Product Change Notification

108448 - 01

Change Notification #: 108448 - 01
Change Title: Intel® IP Network Server NSW1U, PCN 108448-01, Product Discontinuance, Product Code Discontinuance and Replacement Announcement, Reason for Revision: Correct BMC and FRUSDR versions, add CD Mounting Kit
Date of Publication: May 23, 2008

Figure 1. Sheet Metal Changes to add Rail Kit Support

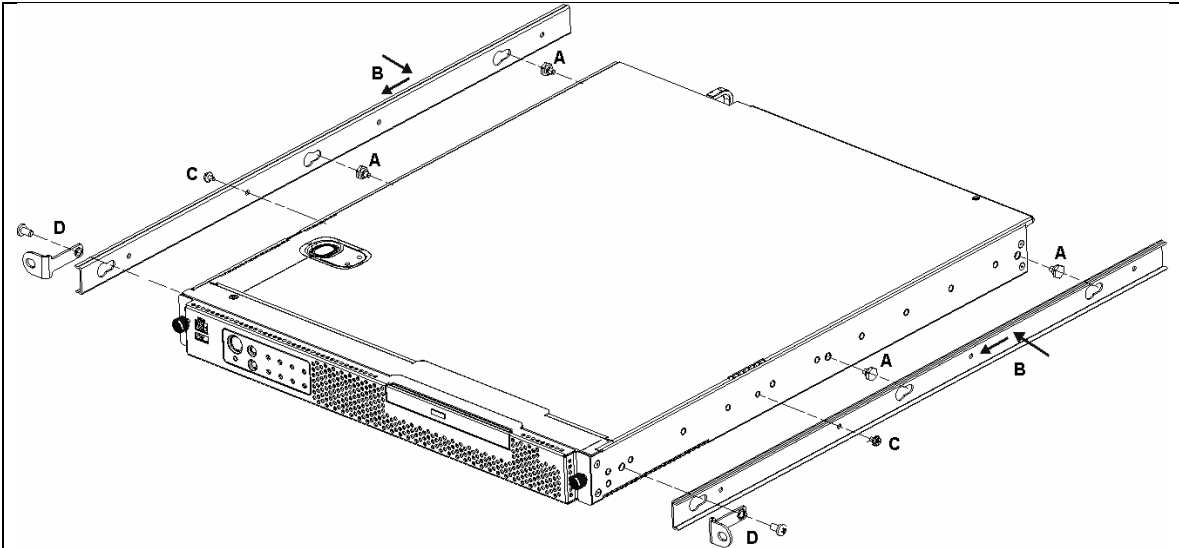
2. Changed base chassis to enable use of AXXBASICRAIL, AXXBASRAIL13, or AXXHERAIL (in non-NEBS environment). Change added:
 - a. Two new positions (A in figure 1 below) per side to add 4 Hex Shoulder Screws.
 - b. Additional position (C and D in figure 1 below) for attaching rail and mounting ear.

Figure 3. Change to Captive Screw on PCI riser assembly

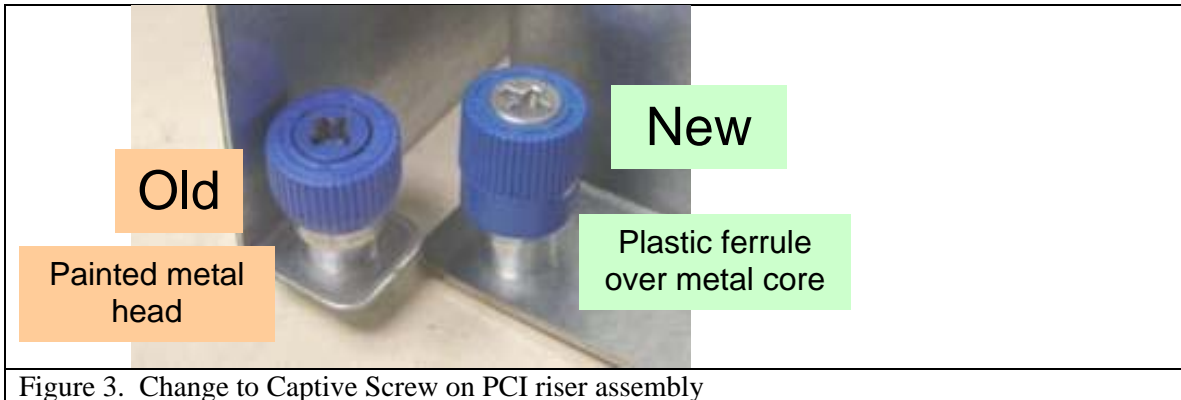
3. Changed Captive Screw type on PCI riser, as shown in Figure 3.
